Subject: AP1000 Response to Request for Additional Information (SRP 6)

RAI-SRP6.2.2-SPCV-04 Rev 1

AP1000 TECHNICAL REPORT REVIEW

RAI Response Number: RAI-SRP6.2.2-SPCV-04
Revision: 1

Figure 6.2.2-1 (Sheet 1 of 2)
Passive Containment Cooling System
Piping and Instrumentation Diagram
(REF) PCCS (R)

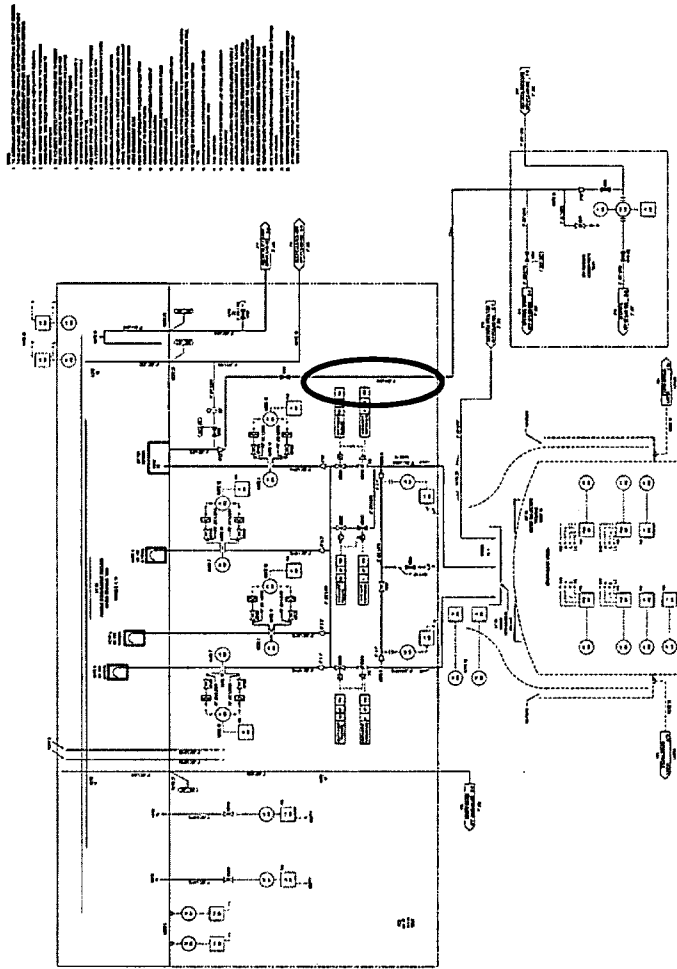
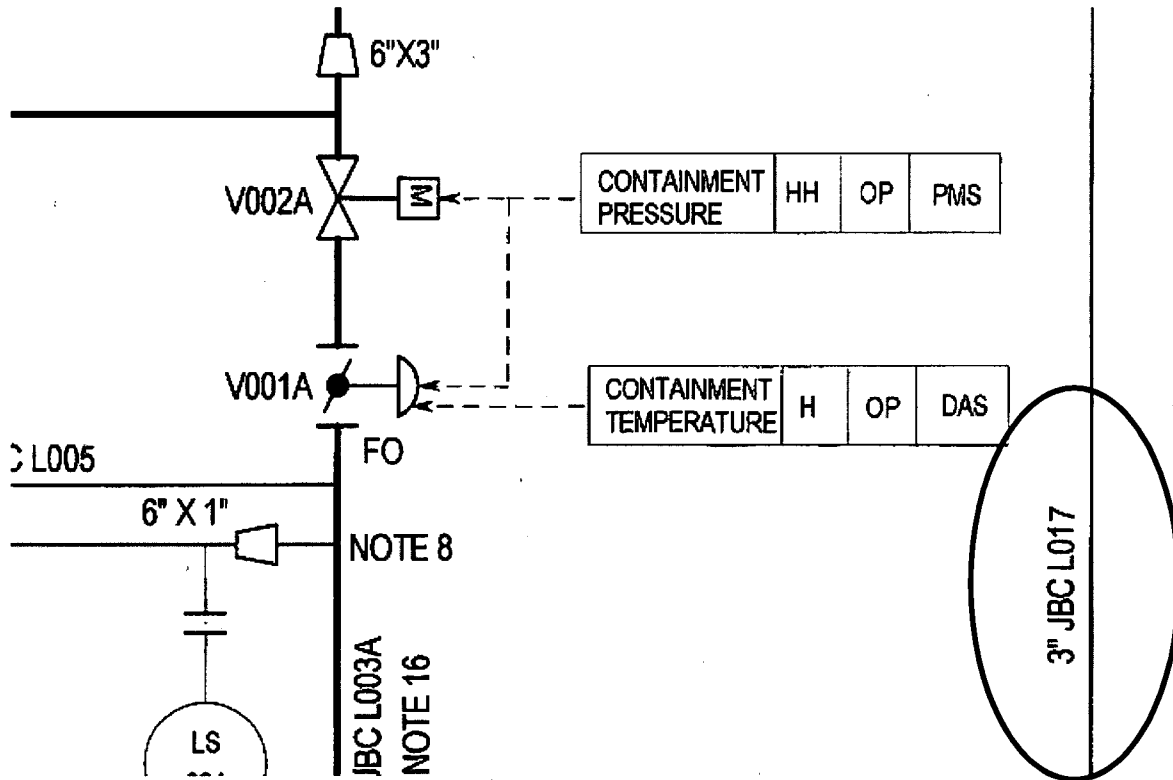
In DCD Tier 1 Table 2.2.2-2, the Line Numbers identified for the last two rows are not consistent with the changes made to Figure 6.2.2-1. Describe any corrections, if necessary, to Table 2.2.2-2.

In response to RAI-SRP6.2.2-SPCV-04, Westinghouse states Tier 1 Table 2.2.2-2 does not have to be changed to reflect changes made to the PCS P&ID (Figure 6.2.2-1 Sh 1 of 2). From Figure 6.2.2-1, it appears that PCS-PL-L048 should be included in Tier 1 Table 2.2.2-2, "Post 72 hr PCCWST Makeup Supply lines," and PCS-PL-L011 should be included in Tier 1 Table 2.2.2-2, "Post 72 hr SFS Makeup Line." For each of these lines, provide an explanation why they should not be included.

The line number for PCS makeup to the spent fuel pool is incorrectly numbered as shown in Figure 6.2.2-1 (Sheet 1 of 2). A DCD revision is required to replace the line PCS-PL-L018 with PCS-PL-L017 in Figure 6.2.2-1 (Sheet 1 of 2). The physical line itself remains the same only the numbering changes. The revision to the DCD is occurring in Tier 2 information NOT Tier 1 information.

After extensive review of the ITAACs in DCD Tier 1 Table 2.2.2-2, and PCS P&ID (APP-PCS-M6-001/002), it has been determined that there are several lines in addition to PCS-PL-L011 and -L048 that would need to be added to Table 2.2.2-2. Also, the pipeline names describing the lines in Table 2.2.2-2 are reworded to enhance clarity.

PCS-PL-L018 is replaced by PCS-PL-L017 on the attached PCS P&ID and detail (Figure 6.2.2-1 Sh 1 of 2).

Circled area shows the markup to occur on Figure 6.2.2-1 (Sheet 1 of 2).
